## STAFF REPORT

**ITEM:** Wyndham Village Subdivision Sketch Plan Review and Comprehensive Plan Amendment

Re: McLeod Residential Subdivision  
Concept Plan Review

**PRELIMINARY GRADING & DRAINAGE PLAN  
LAKE ELMO RESIDENTIAL**

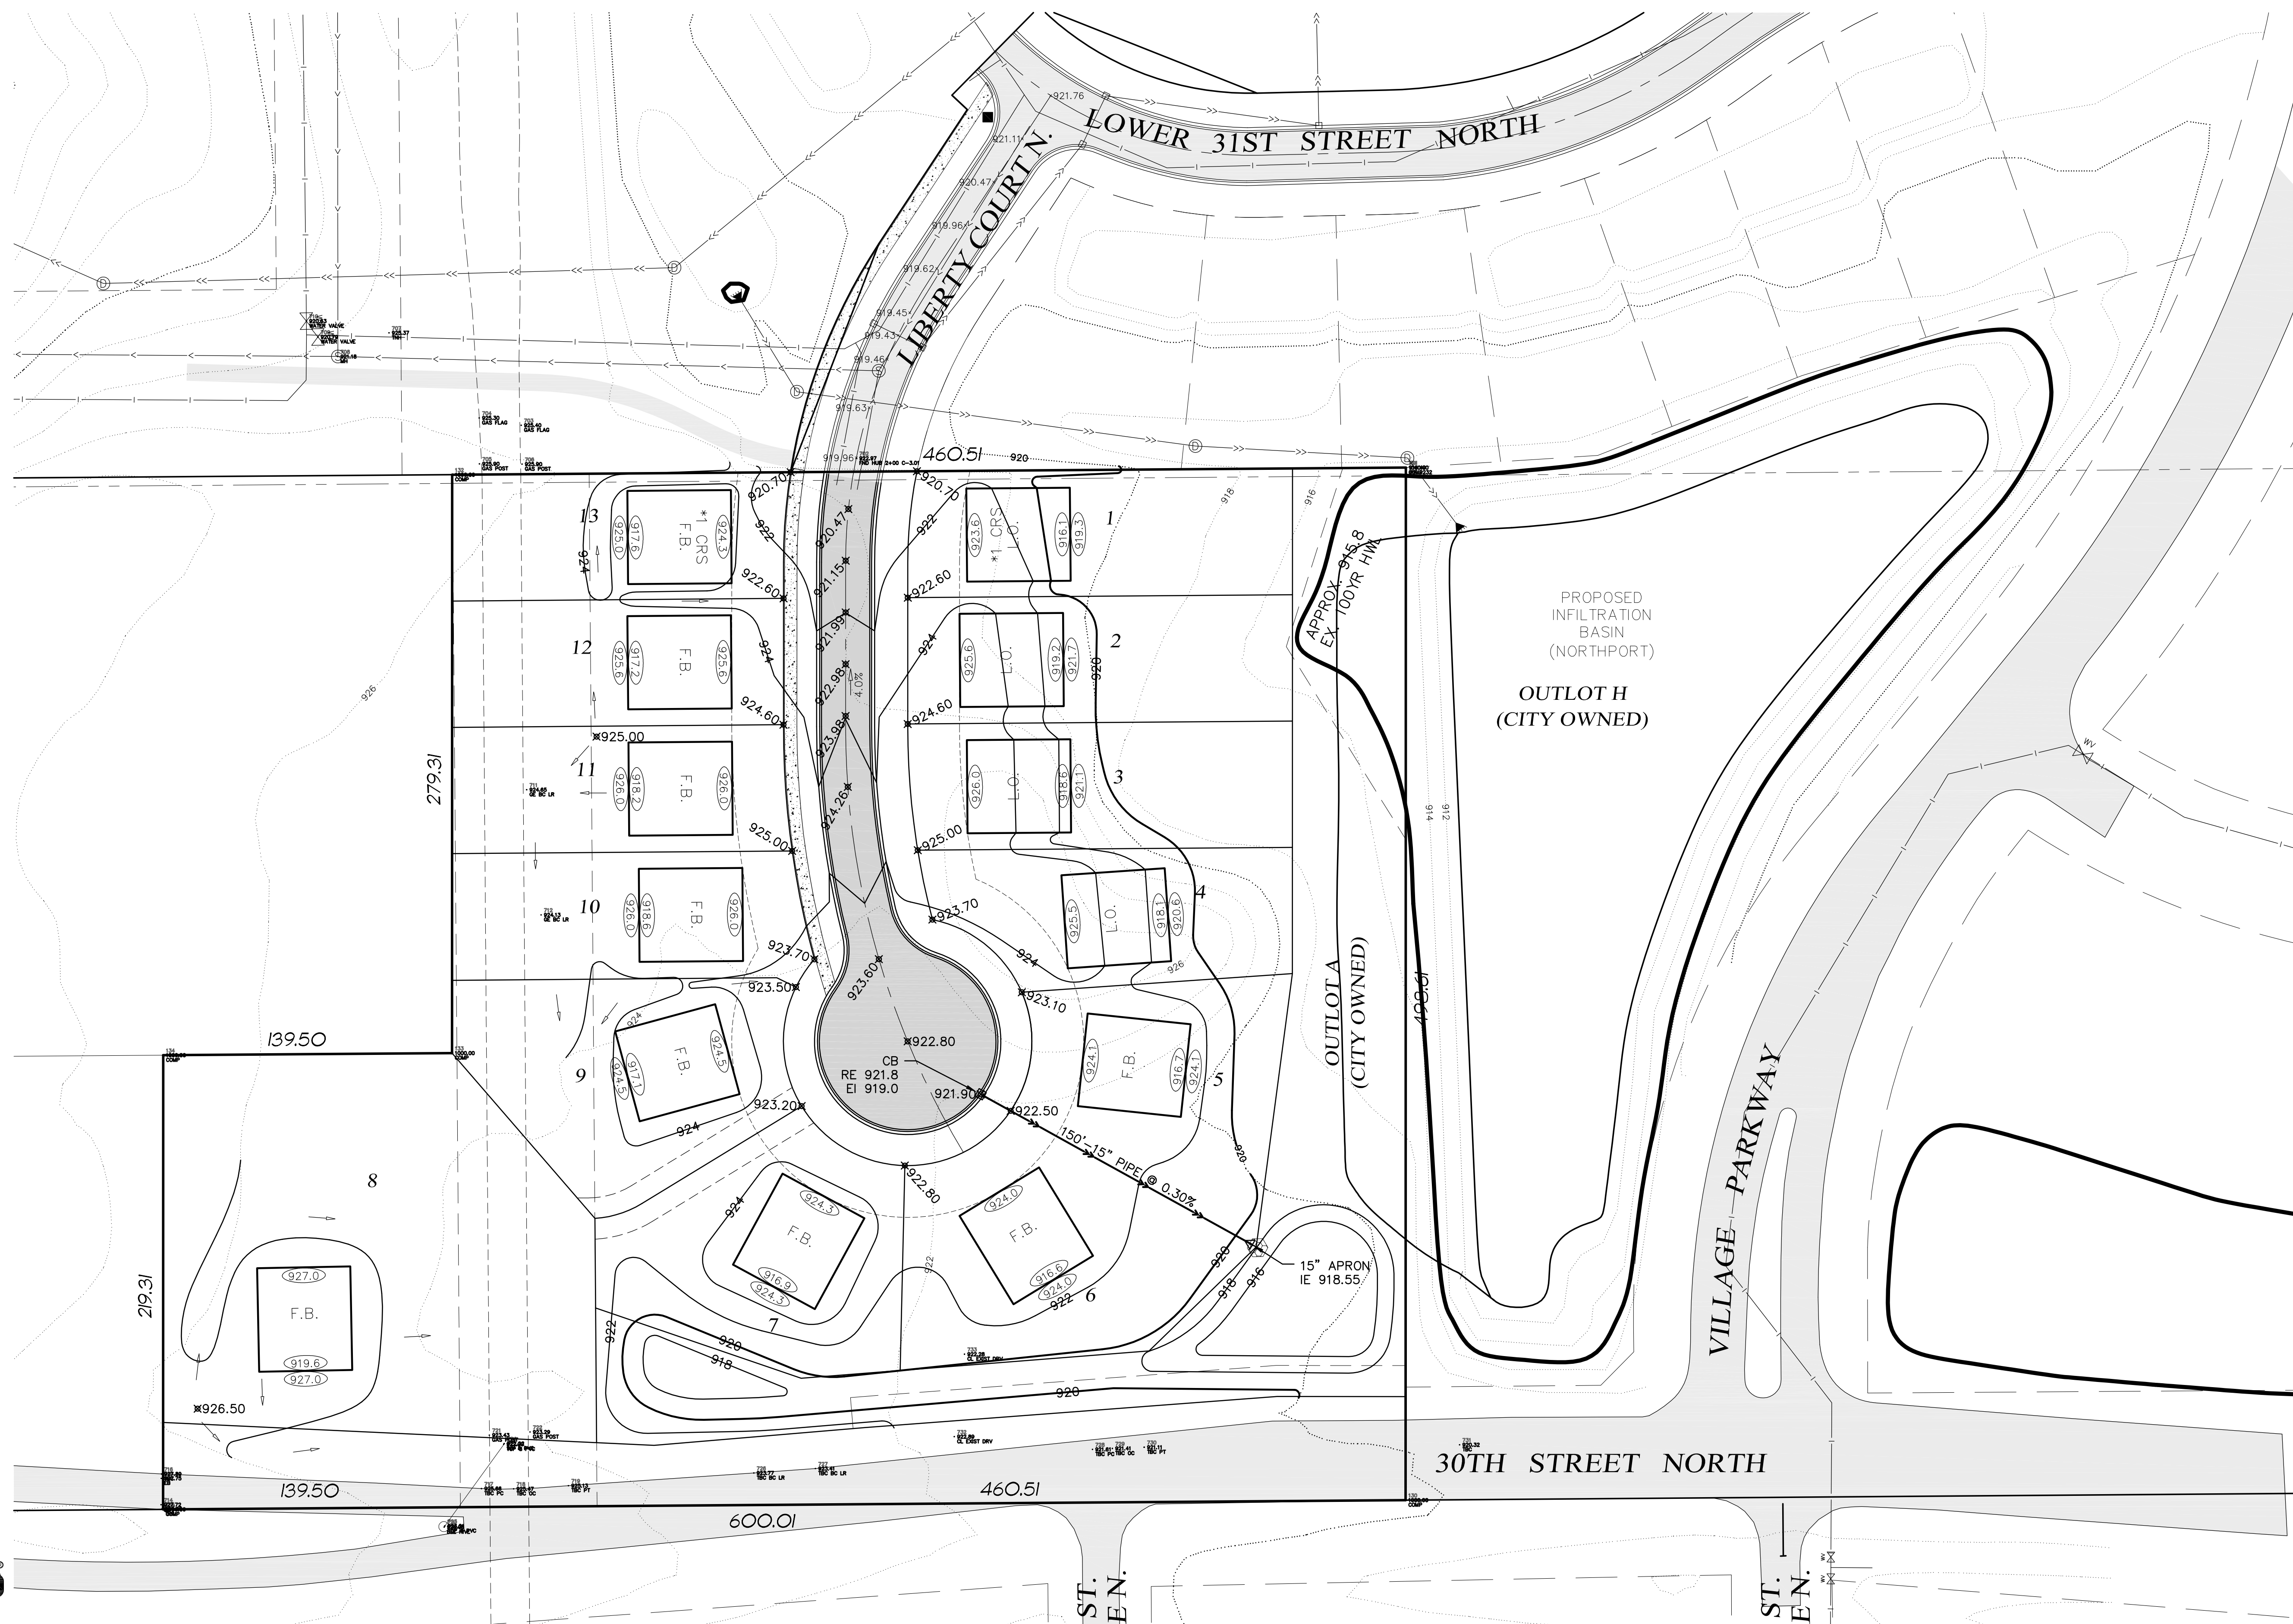
- More land area is likely needed to be allocated for storm water management. The preliminary grading plan already shows pond encroachment onto Lots 6 and 7. Also, additional pond depth must be provided to meet City pond construction requirements.

- Overland emergency overflows or outlets will be required as part of the site plan.
- Grading restrictions along the Northern Natural Gas easement must be adhered to as part of the development plans. It is unclear how drainage within the NNG easement will be captured and conveyed to the storm water facilities.

- Liberty Court drainage must be captured and treated on-site. A significant portion of the street is shown draining to the Northport subdivision. The Northport storm water management plan does not account for this additional impervious areas.

- Per City requirements all storm sewer pipe easements must be a minimum 30-feet in width. No drainage and utility easement is shown for the storm sewer pipe along the Lot 5 and Lot 6 property line.

# LOW DENSITY RESIDENTIAL - CONCEPT SUBDIVISION

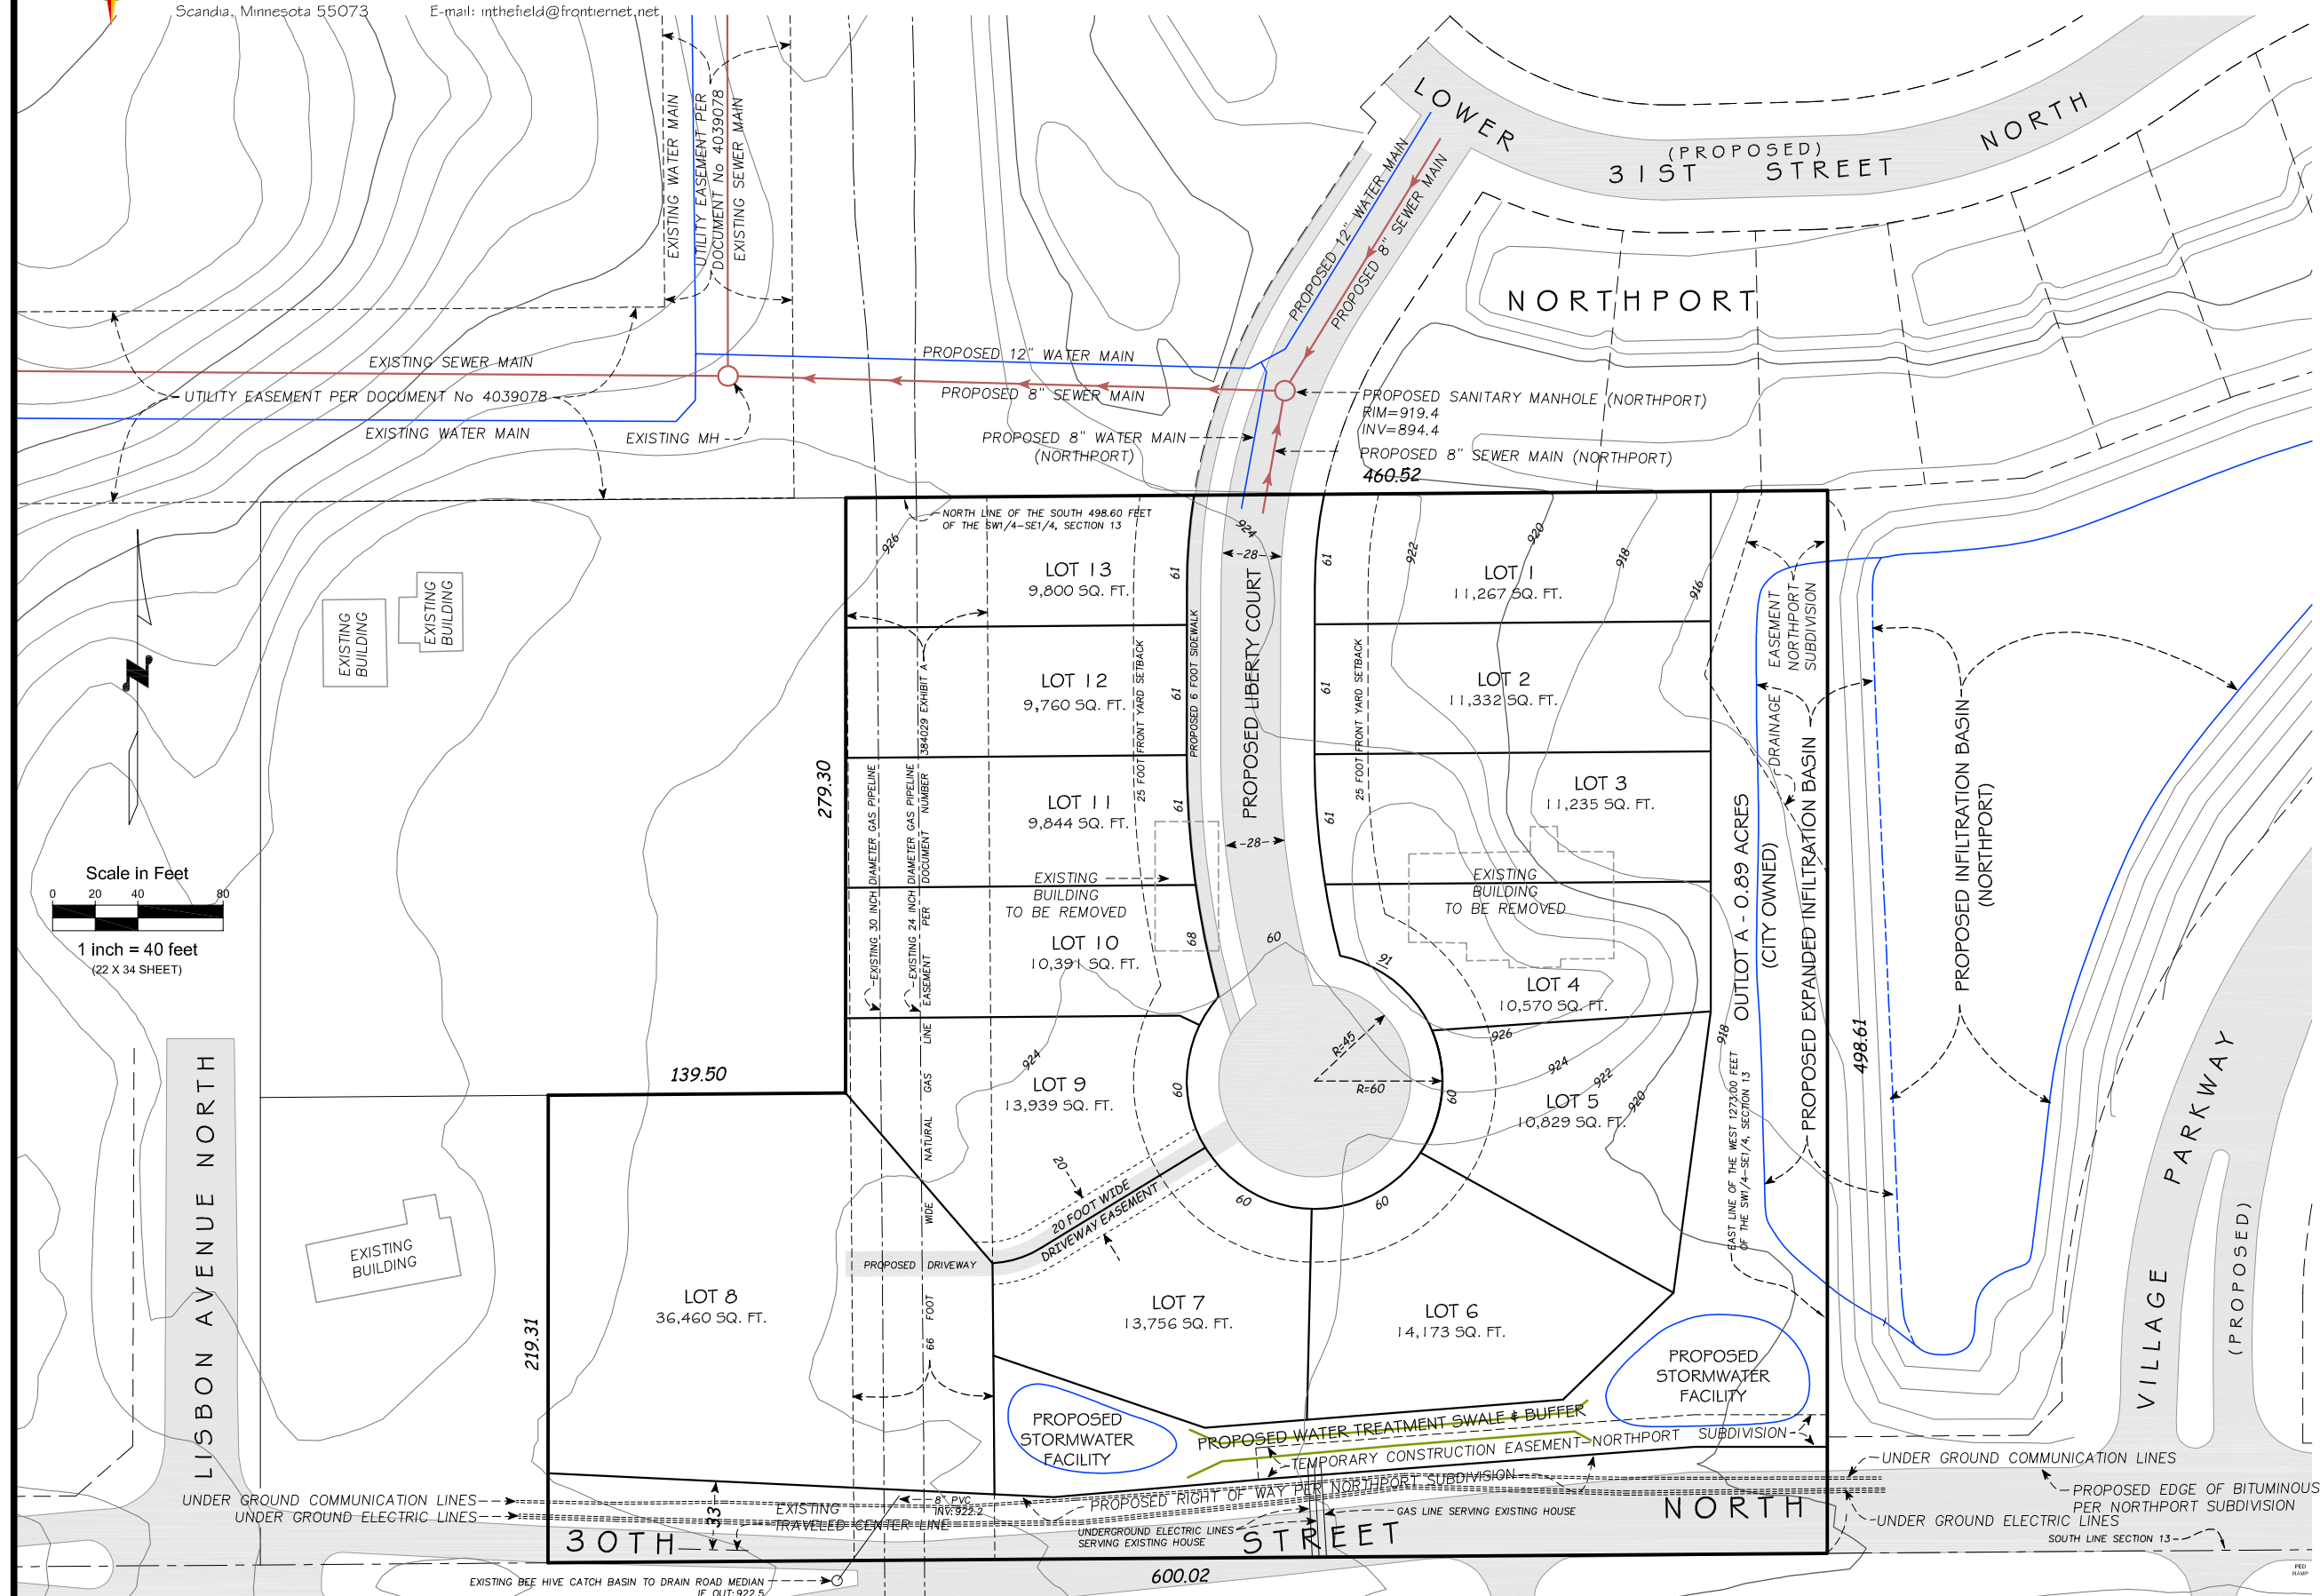
- Access Management. The Concept plan shows access to the plat from the Northport subdivision along Liberty Court. This access was pre-planned with the adjacent subdivision and preserves the proper access management along 30th Street North.

- Right-of-way dedication. The Plat must dedicate additional right-of-way along 30th Street North to ensure a minimum 30th Street boulevard of 16 ft. along the entire length of the plat. In addition a 10 ft. utility corridor must be reserved (at boulevard grades) for small utilities. The proposed Stormwater facilities (including the 100-year HWL) cannot encroach the 10 ft. utility corridor.

- Screening along 30th Street is recommended. The south boundary of the subdivision is along the north boulevard of 30th Street North and proposes two storm water ponds connected by a drainage swale. It is recommended that additional space be allocated at elevations higher than 30th Street to create a vegetative buffer between the lots and this collector street.

- Lots 9-13 include large areas of gas main easement with 2 large diameter gas mains. There is no useable rear yard along these lots.
- Lot Easements (front, rear and side yard) should be shown on the plans meeting City requirements.

- Lot 8 is proposed to access Liberty Court with a 20 ft. driveway easement on Lots 7 and 9. It is recommended that this easement be revised as a 30 ft. minimum width Outlot to be owned by Lot 8.
